Change Order, Construction Manager as Adviser Edition

Christian County High School
5185 Fort Campbell Blvd
Hopkinsville, KY 42240

Change Order Number: 098
Date: December 15, 2025

Project:	Christian County High School 5185 Ft. Campbell Blvd Hopkinsville, KY 42240	PR No.:	058
		Date:	September 2, 2025
Owner:	Christian County Public Schools 222 Glass Ave Hopkinsville, KY 42240	Project Number:	2106-204
		Contract for:	
To:	Kevin Hitchell Alliance Corporation 116 E. College Steet Glasgow, KY 42141		
RE:	Area J & G Modifications

**POWER PLAN - FIRST FLOOR
- AREA 'G'**

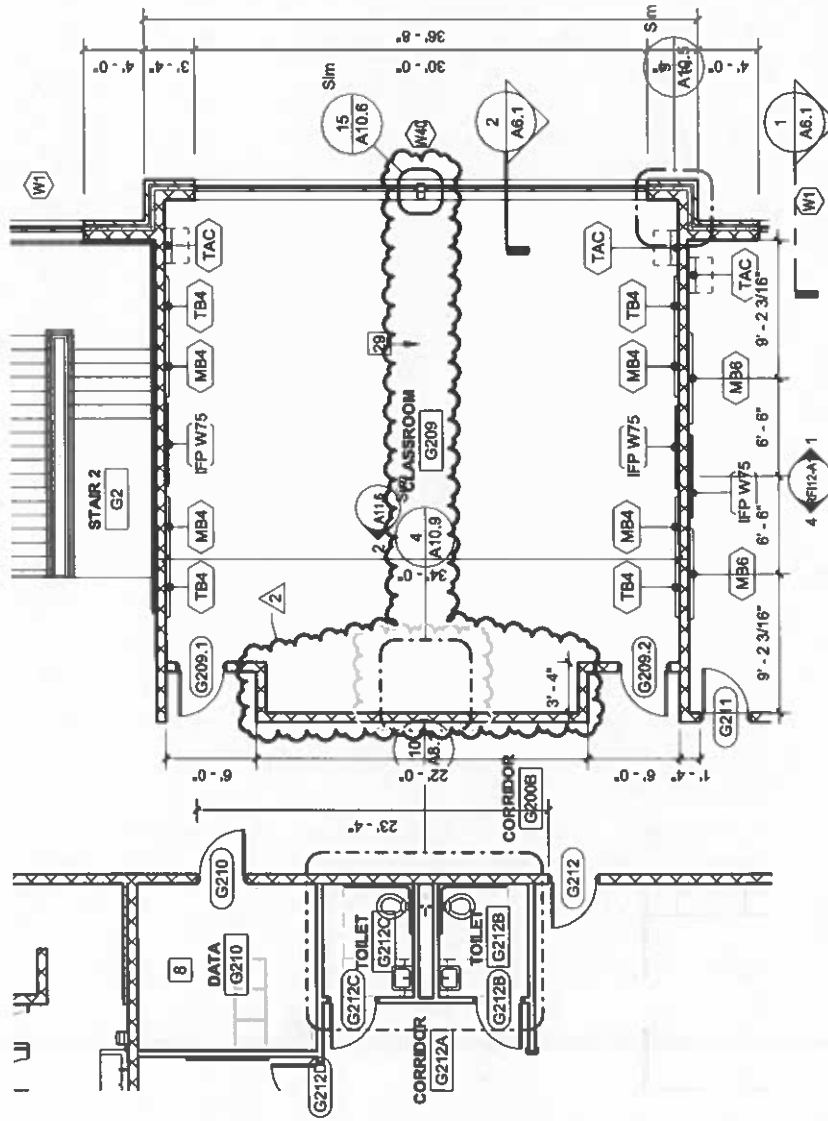
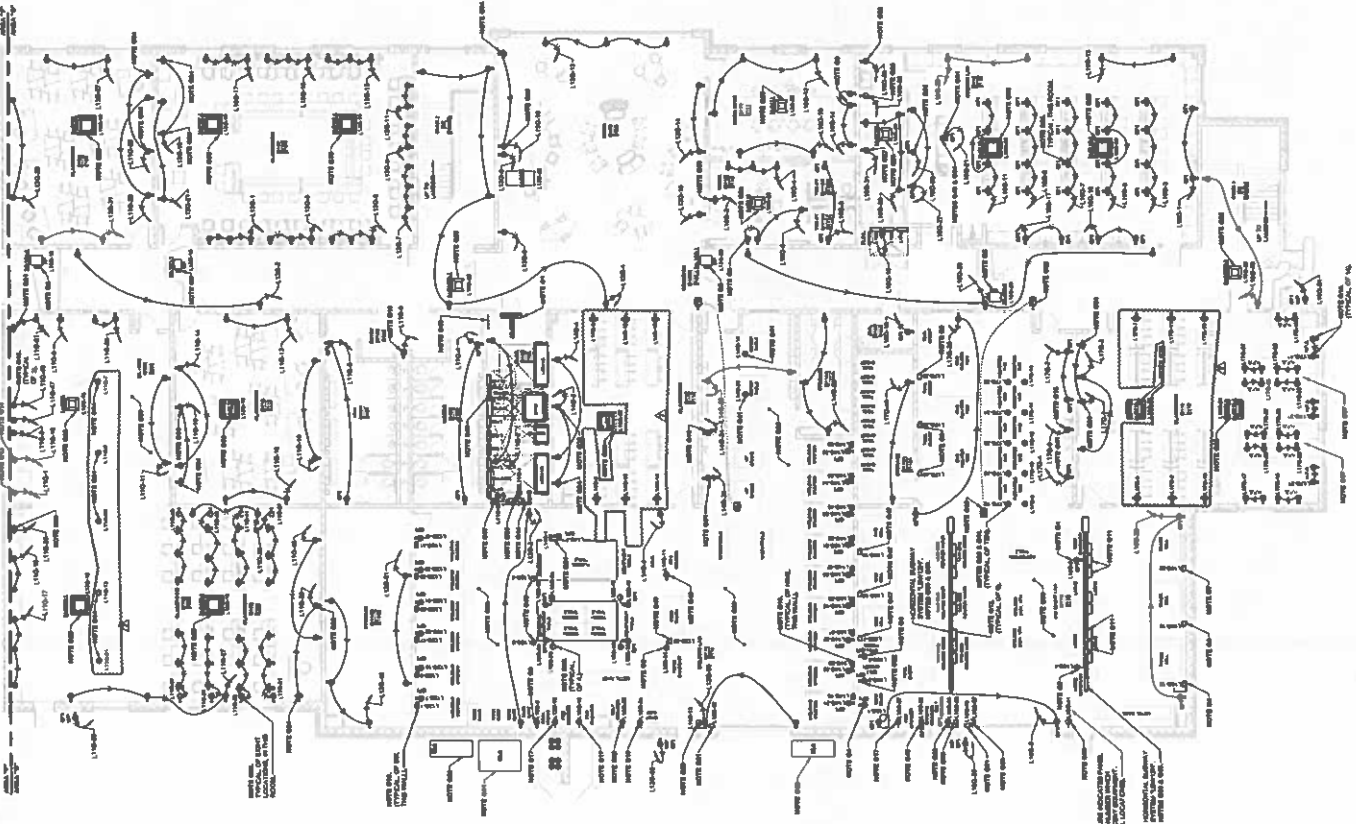
- 3) Reference revised drawing E1.1 Rev. 4, Multi-Function Floor Box / Poke-Thru Assembly Schedule. Added type 2C.
- 4) Reference revised drawing E1.9 Rev. 2. Added detail for Cord reel Installation in Grid Ceiling.
- 5) Reference revised drawing E2.1G Rev. 3:
 - a. LT-CTE G106. Deleted the four receptacles at each of the five work tables and added a cord reel assembly (within the T-Grid system) at the locations where the five workstations were removed.

- b. Classroom G112. Changed power feed to receptacles within furniture system to receptacles installed within the wall.
 - c. Classroom G118. Changed power feed to receptacles within furniture system to receptacles installed within the wall.

- d. Added note G64.
- 6) Reference revised drawing E2.1H Rev. 5:
 - a. Construction Instruction J102. Changed power feed to receptacles within furniture system to receptacles installed within the wall.

**BUSSING DIAGRAMS - BLDG
AREA 'G' (2ND FLOOR) -
NORMAL POWER**

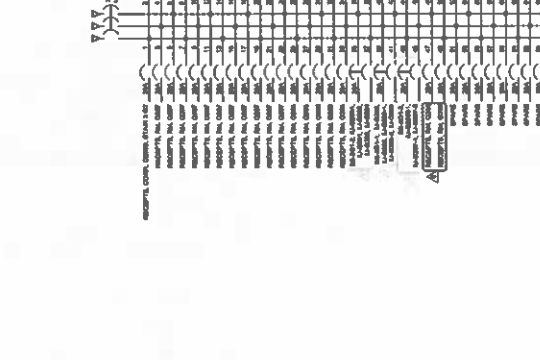
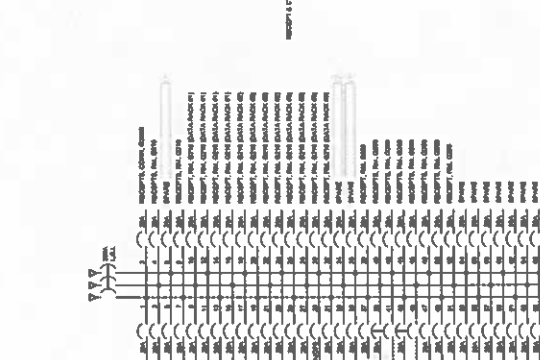
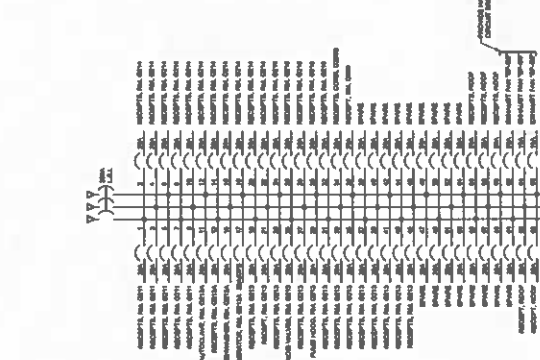
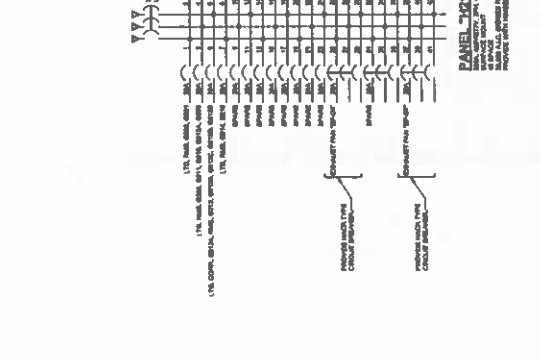
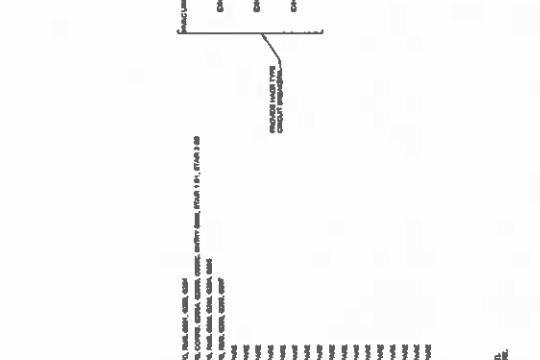
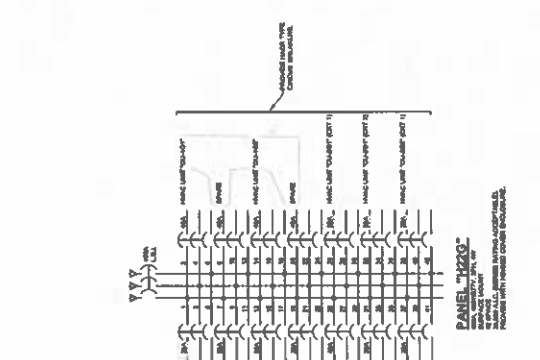
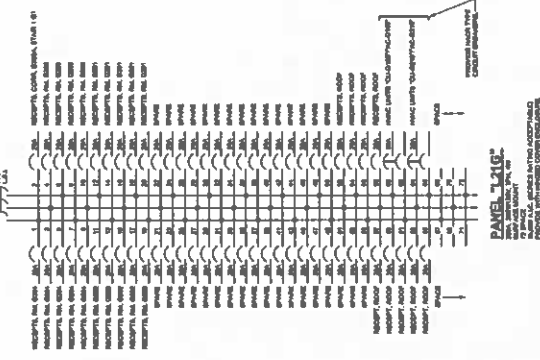
- 8) Reference revised drawings E2.2G Rev. 4 & E6.10 Rev 5\;
 - a. Classroom G206:
 - i. Deleted power feeds from two type 2B poke-thru devices to the receptacles within furniture system.

- ii. Deleted power circuits (qty 6) to the two type 2B poke-thru devices. (Note: These circuits will be reused to feed the new poke-thru device locations within Graphic Design room 208).

- iii. Deleted two type 2B poke-thru devices. (Note: If the poke-thru devices have been installed, then Blank cover plates shall be provided.
 - b. Graphic Design room G208:

- i. Added a quantity of eight type 2C poke-thru devices.
 - ii. Added a quantity of two 120V, 20A branch circuits and reworked a quantity of 6 120V, 20A power feeds to the new poke-thru devices.

- iii. Added circuits from the eight new poke-thru devices to the furniture system raceways.
 - c. Deleted note G32.
 - d. Added notes G34 & G35.
 - e. Classroom G209. Removed receptacles from four locations and converted the outlet boxes to furniture system power raceway feeds. The two circuits which feed the furniture system power raceways shall be the same two circuits which feed the receptacles on the same wall as the furniture system..
